**Supplement to the Request for Amendment to Certificate of Compliance No. 71-9248 for the Model No. SP-1, SP-2 and SP-3 Packages (EMF-1563 Revision 12A)**

EMF-1563  
Revision 12A

Consolidated License Application for  
Framatome ANP, Inc. Model SP-1,  
SP-2, and SP-3 Shipping Containers

### Nature of Changes

Figure 1  
Comparison of Reactivity for Reduced Enrichment,  
No Burnable Poison(s) vs. Base Case

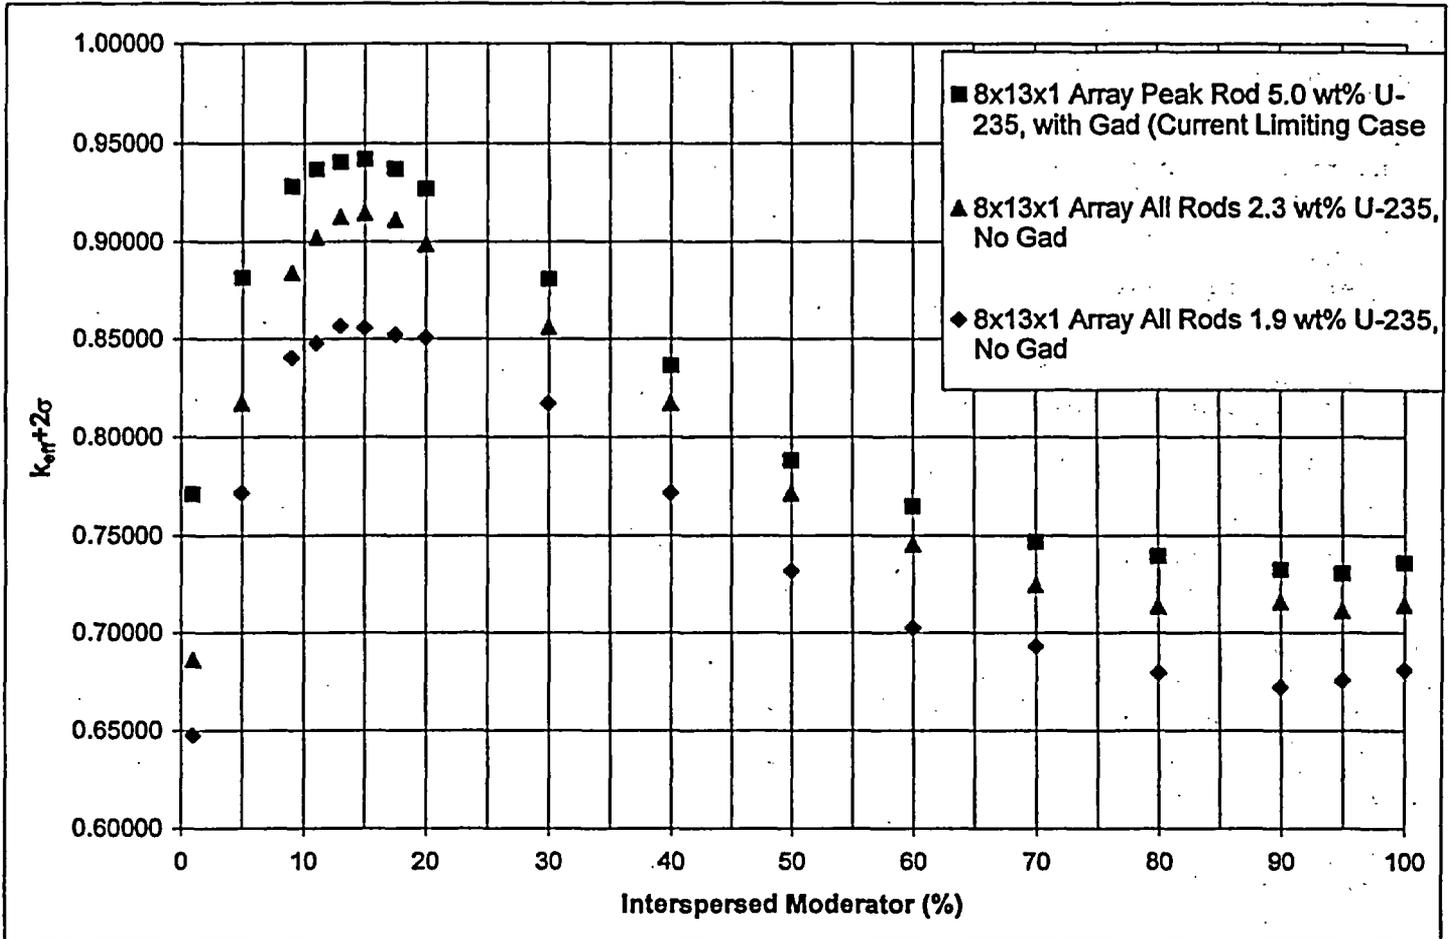
In order to demonstrate that the conditions resulting in the maximum reactivity did not change due to the reduction in enrichment or exclusion of poison material, the worst case accident case was evaluated over the entire range of interspersed moderator, from 1% to a full flooded condition. Figure 1 demonstrates the system is well behaved as evidenced by the consistency in the curves. For comparisons to the previously transmitted values, Table 1 contains reactivity values for both the existing licensed conditions, and those proposed in this appendix.
